Subject: AP1000 COL Response to Requests for Additional Information (TR #37)

In support of Combined License application pre-application activities, Westinghouse is submitting a response to the NRC request for additional information (RAI) on AP1000 Standard Combined License Technical Report 37, APP-GW-GLN-003, Hydrogen Igniter Locations. This RAI response is submitted as part of the NuStart Bellefonte COL Project (NRC Project Number 740). The information included in the response is generic and is expected to apply to all COL applications referencing the AP1000 Design Certification.

Response to Request for Additional Information on Technical Report No. 37

RAI-TR37-001

Figure 6.2.4-5

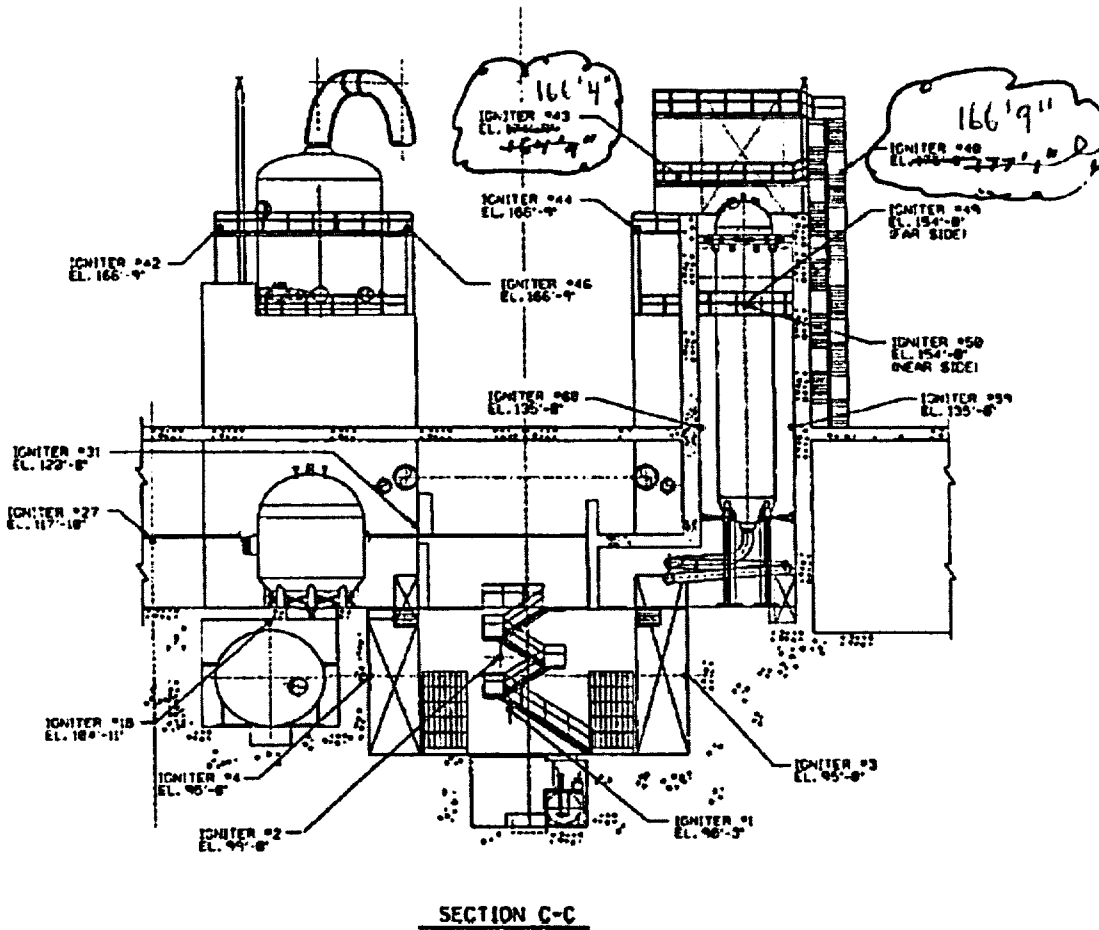
c) Section III, DCD Mark-Up, of TR37 will be updated to reflect the latest igniter #40 and #43 elevation changes identified in TR36 for DCD Figures 6.2.4-5, 6.2.4-11, and 6.2.4-13 that were superseded by TR36 changes. The igniter elevation changes in these three TR36 figures were approved and submitted to the NRC after TR37 was submitted, so they correctly supersede the TR37 version of these figures.

(TR 36 also identified that there was an inconsistency in the original elevation of igniter #40 in DCD Figure 6.2.4-5 that was shown to be 175'8" while the correct original elevation was shown in DCD Figure 6.2.4-11. This inconsistency was corrected but not discussed in the original TR37 markups and is also corrected in the revised TR37 markups for this RAI response.)

Revise Figure 6.2.4-5 as follows:

Figure 6.2.4-12

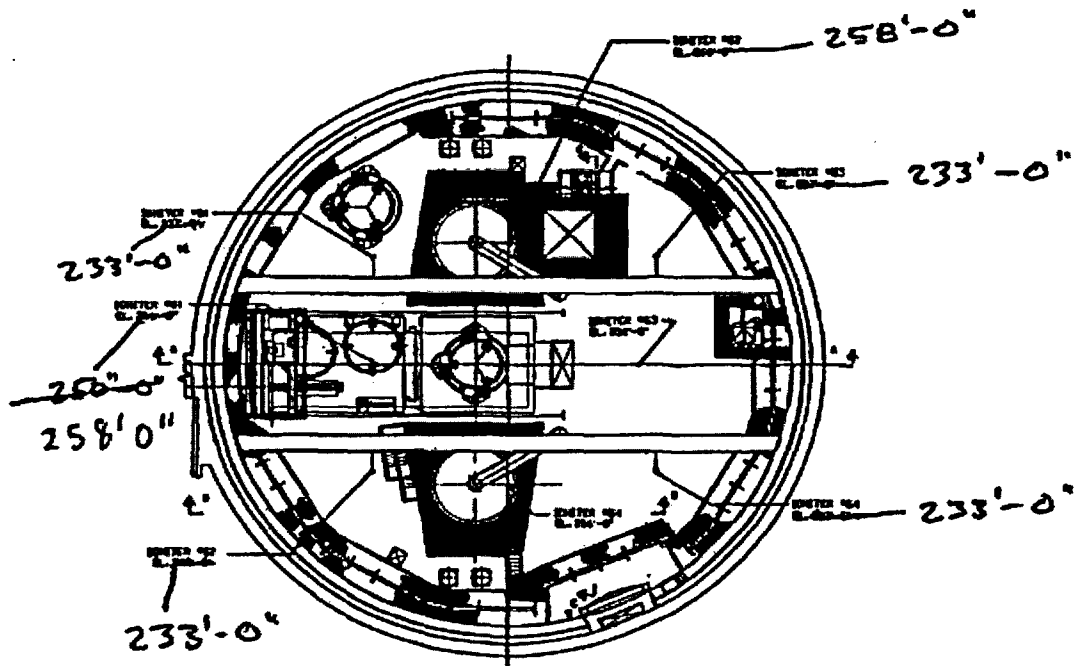
d) The markup for Figure 6.2.4-12 for TR37 incorrectly revised the elevation for igniter #61 to 250'0" instead of 258'0" which was inconsistent with TR37 markup for Figure 6.2.4-13. The corrected markup for Figure 6.2.4-12 is provided to reflect 258'0".

Figure 6.2.4-12 Revise Figure 6.2.4-12 as follows:
